**Errata for**  
*Introduction to Structural*  
*Dynamics and Aeroelasticity, Second Edition*

Dewey H. Hodges and G. Alvin Pierce  
Errors in Fifth Printing (to be corrected in Sixth Printing)

October 16, 2018

Figure 4.4: Plot of  $1/\theta$  versus  $1/q$

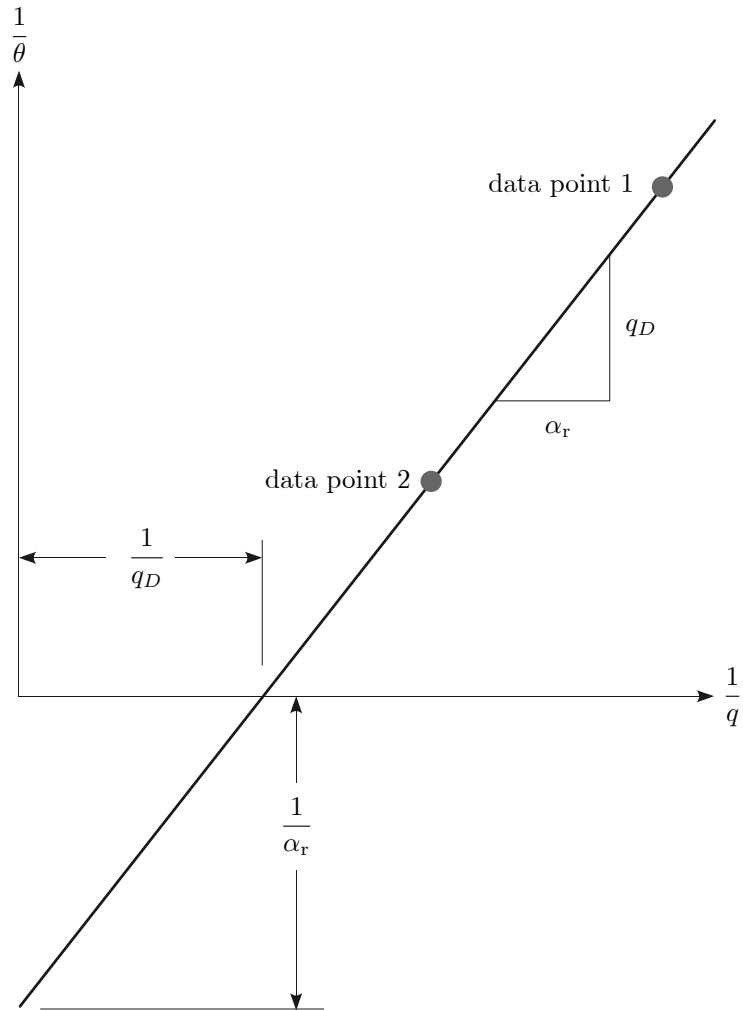
132 The slope indicated for the line in Fig. 4.4 should be  $q_D/\alpha_r$  as indicated herein.
